AppSer. No. 09/854,172

AUTO-ADJUST NOISE CANCELING MICROPHONE WITH  
POSITION SENSOR  
Inventors: Robert J. Bernardi, et al.

Reply to Office Action of July 9, 2008  
Annotated Sheet showing changes

FIG. 1

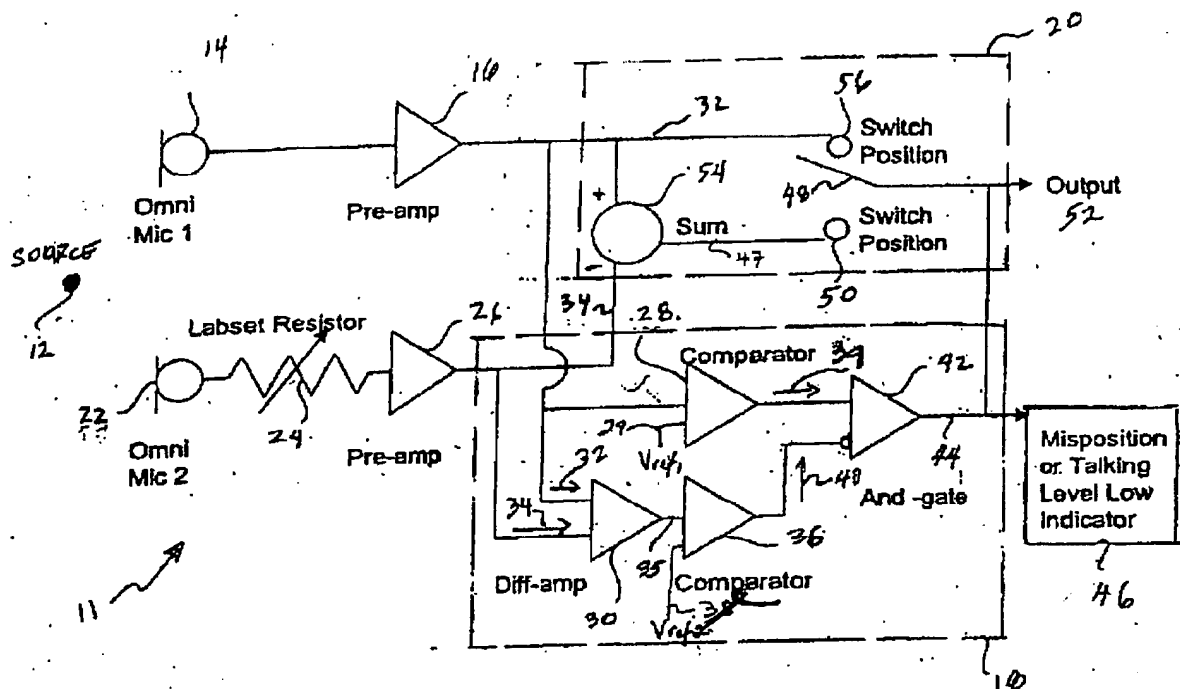
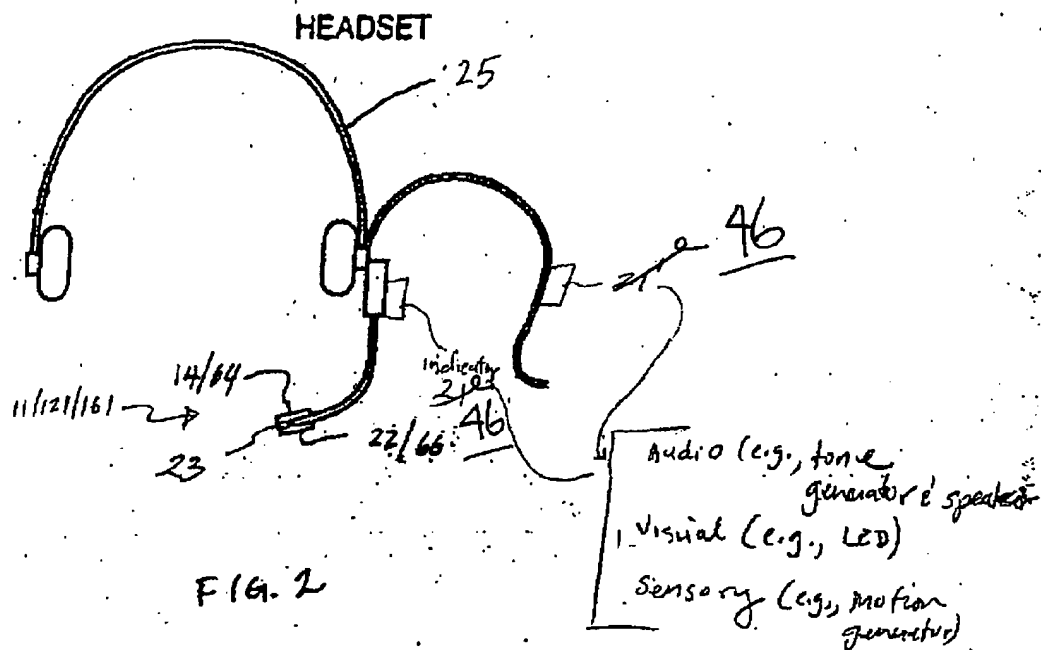
Some minor errors are also corrected in FIGS. 1-3. In particular, in FIG. 1, reference number 38 is removed as the specification does not contain reference to 38.

FIG. 3

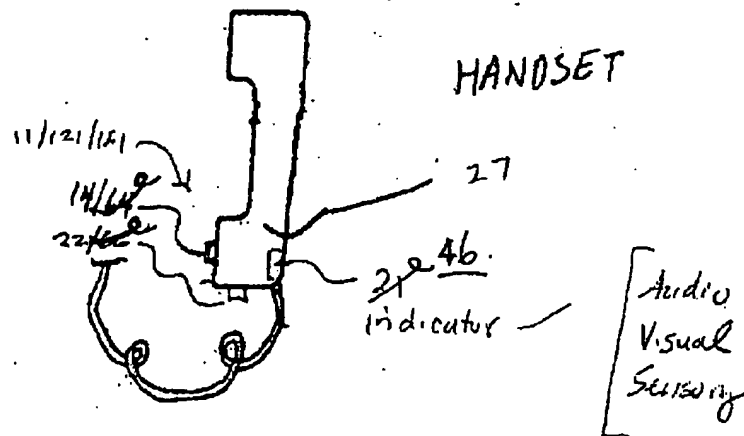
In both FIGS. 2 and 3, reference numbers 64 and 66 are removed as the specification does not contain reference to 21, 64, or 66. In addition, in both FIGS. 2 and 3, each instance of reference number 21 is corrected with reference number 46.
